Architectural Review and
Historic Preservation Board
Agenda Report

Meeting Date 06/02/2021

File: AR 20-18

RE: Architectural Review 20-18 (AMPM Gas Station);
A portion of APN 006-690-022

PROPOSED MINI-MART & FUEL ISLAND
 15 W. EATON ROAD, CHICO, CALIFORNIA 95973
 TRASH ENCLOSURE ELEVATIONS

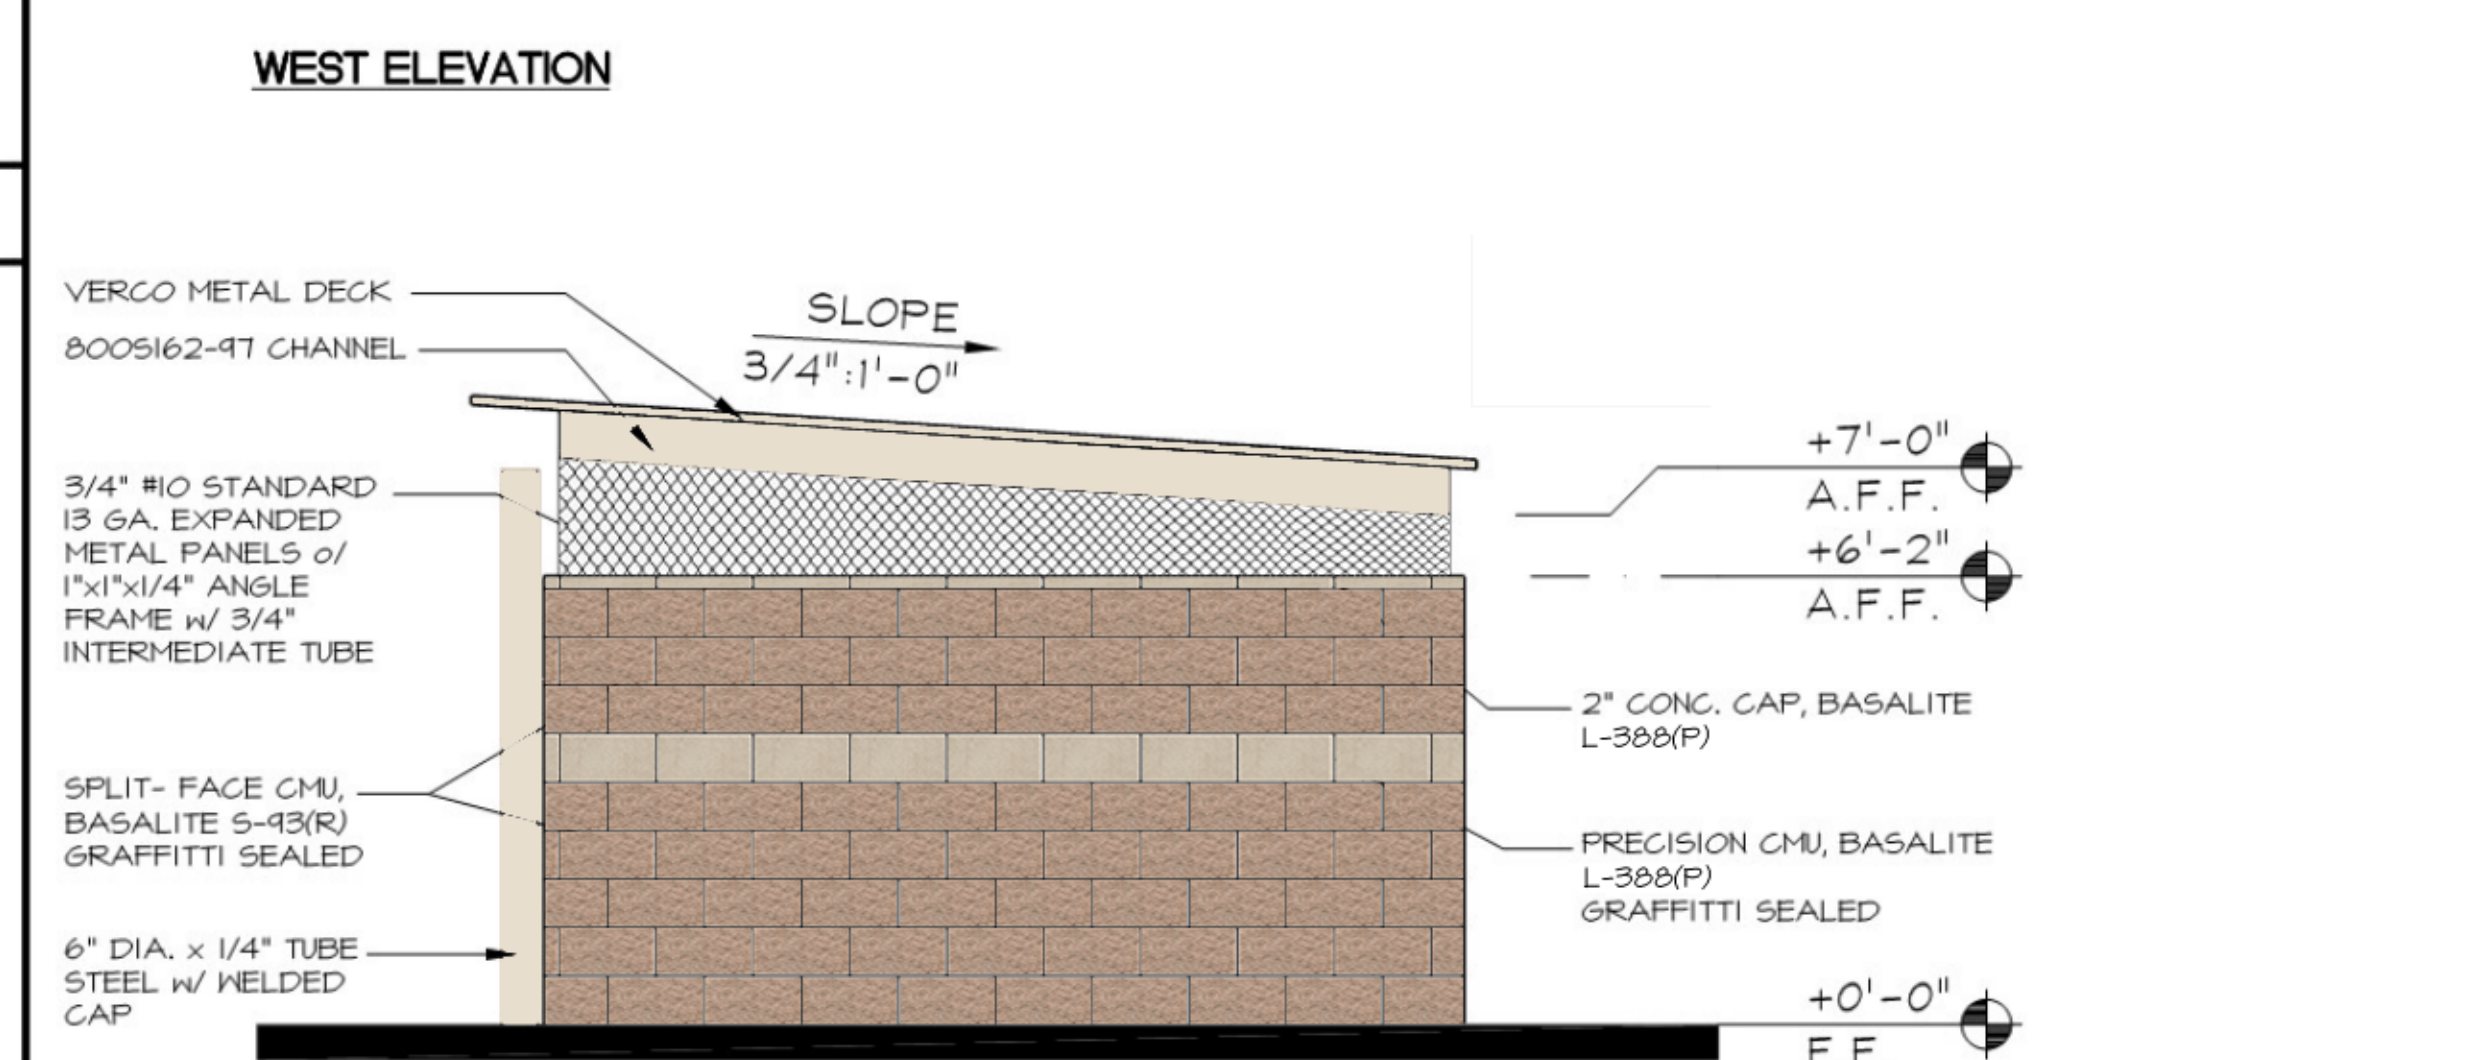
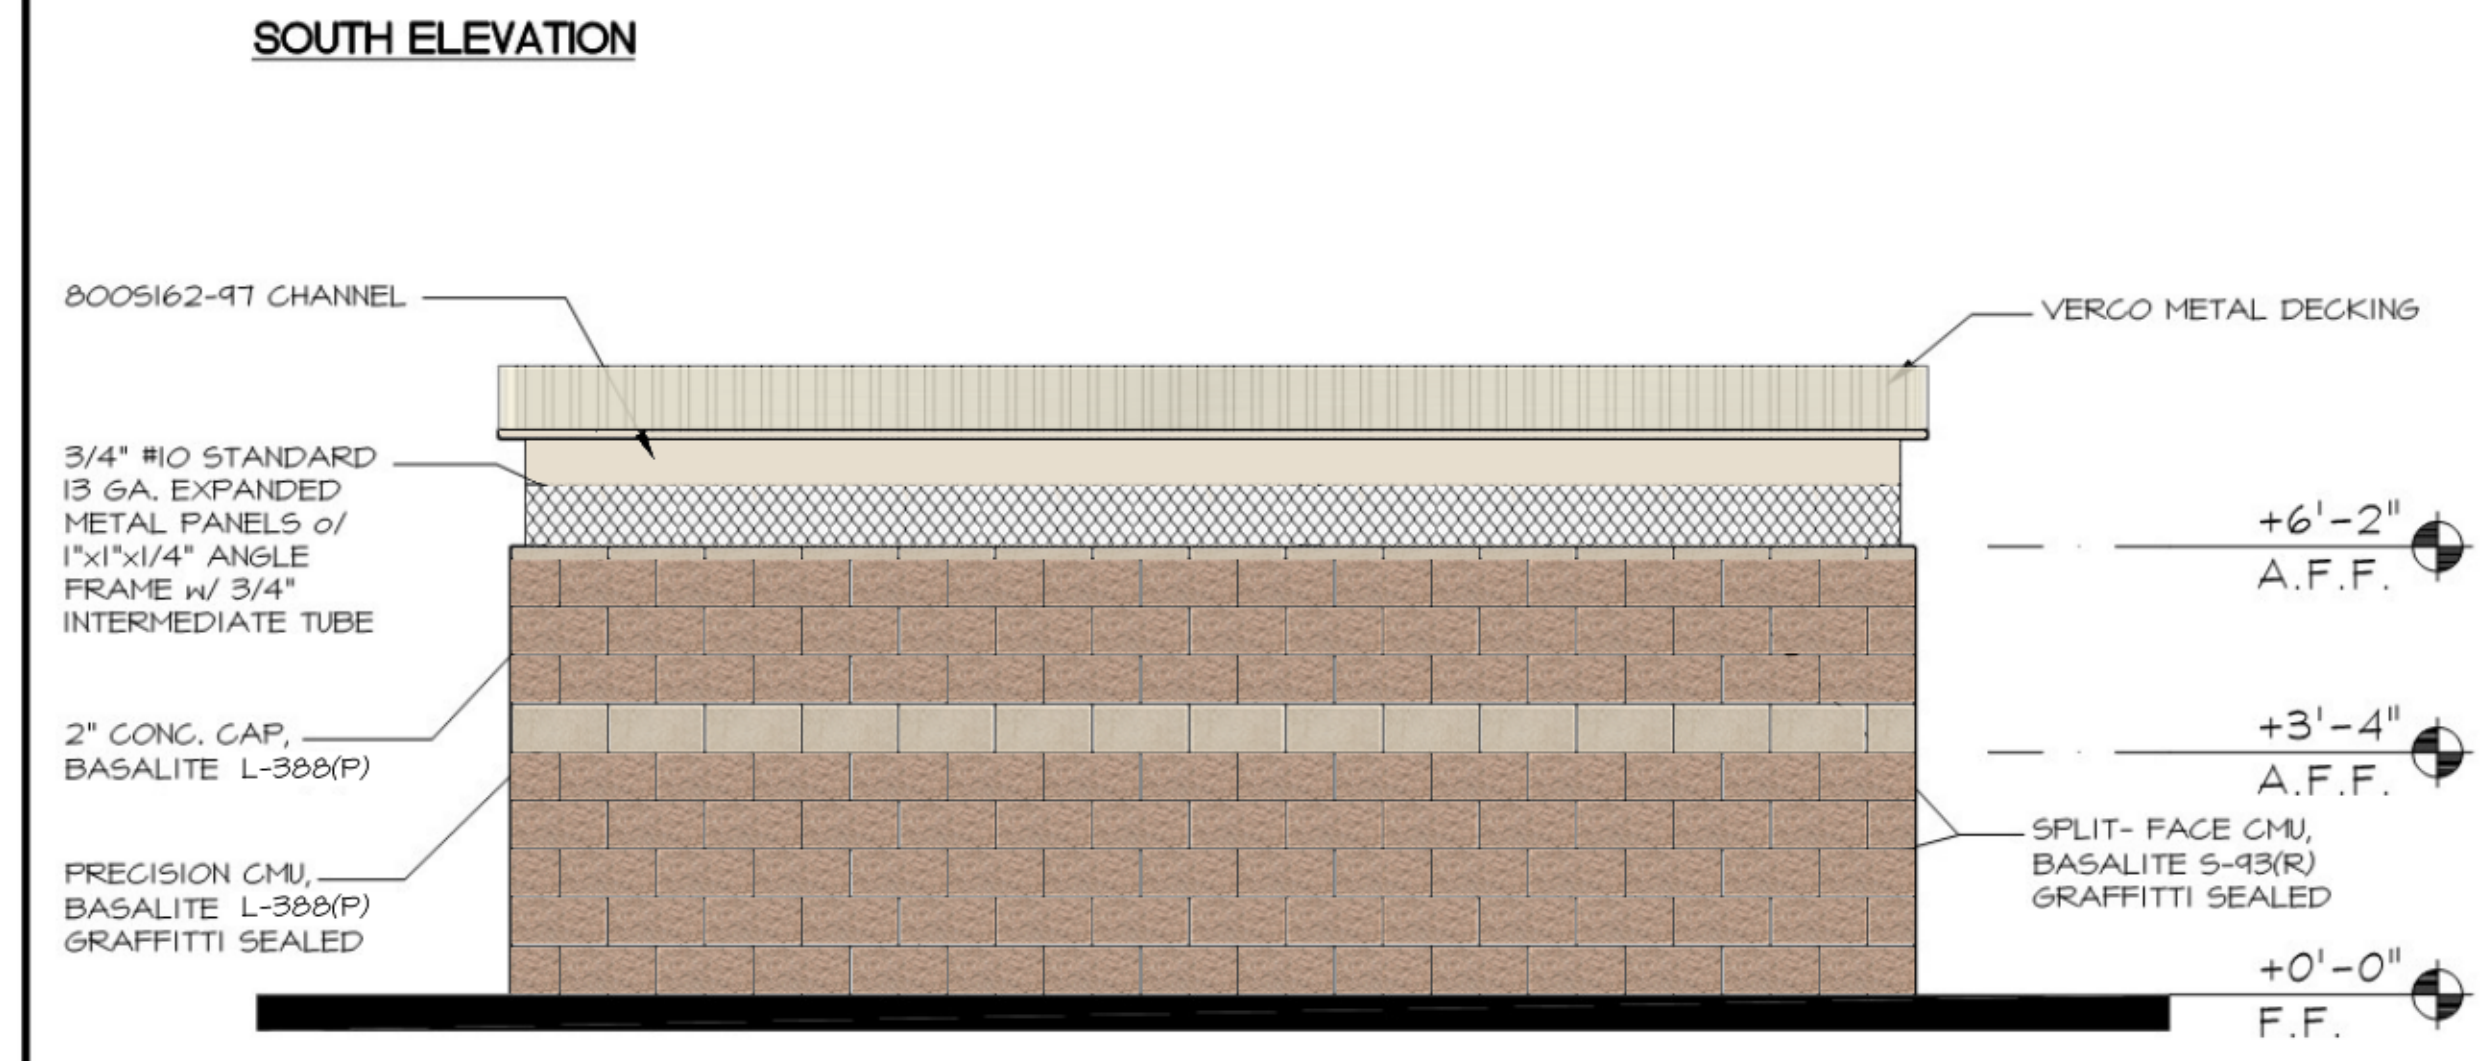
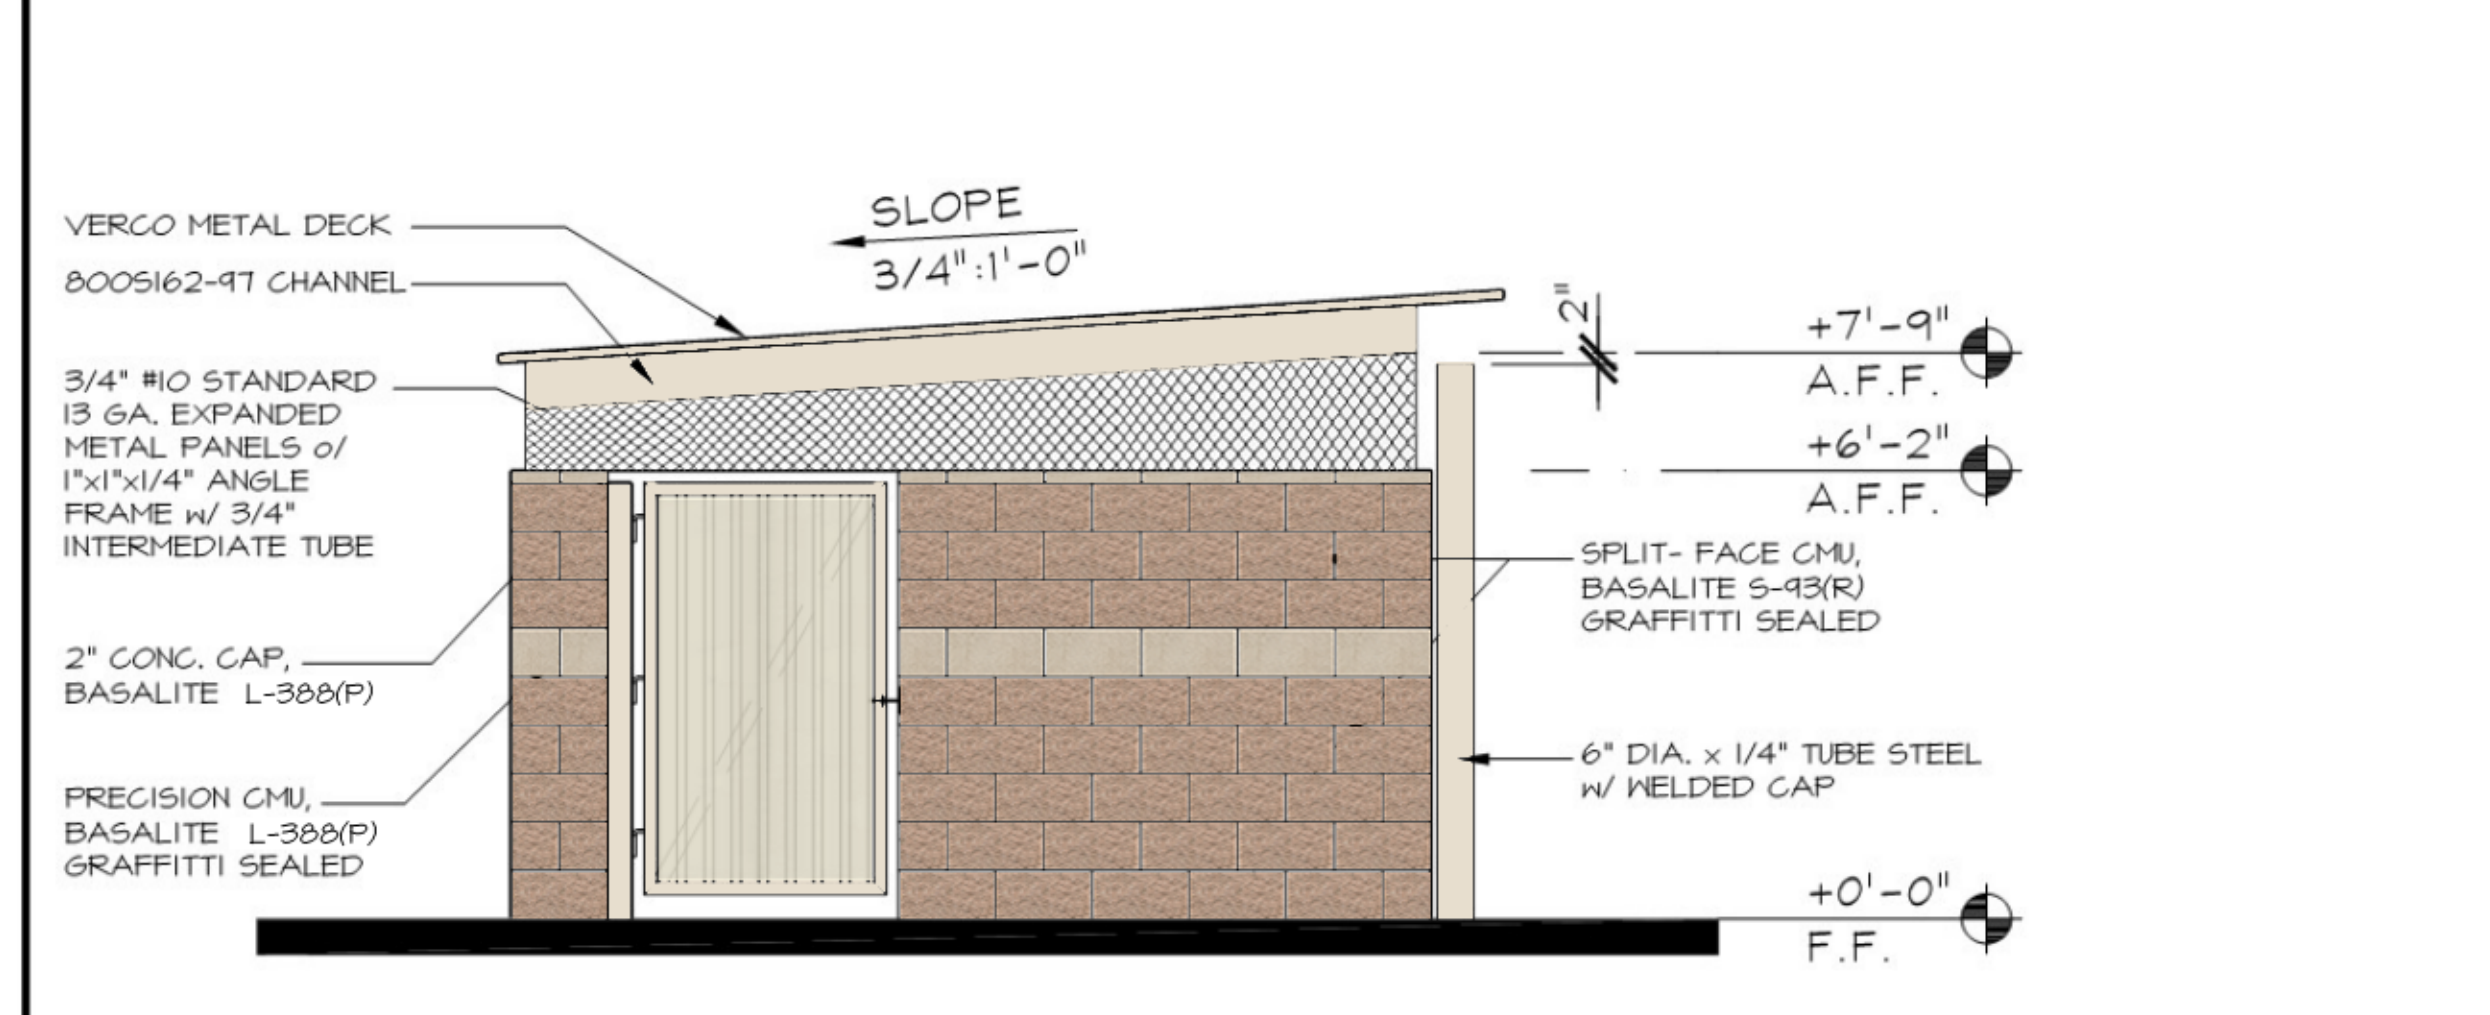
6. Wall-mounted trellis panels with climbing vines shall be incorporated on the rear (south) and east side elevations of the proposed convenience store building, and on the north side of the trash enclosure. These features shall be shown on the final landscaping plan to be submitted with building plans.
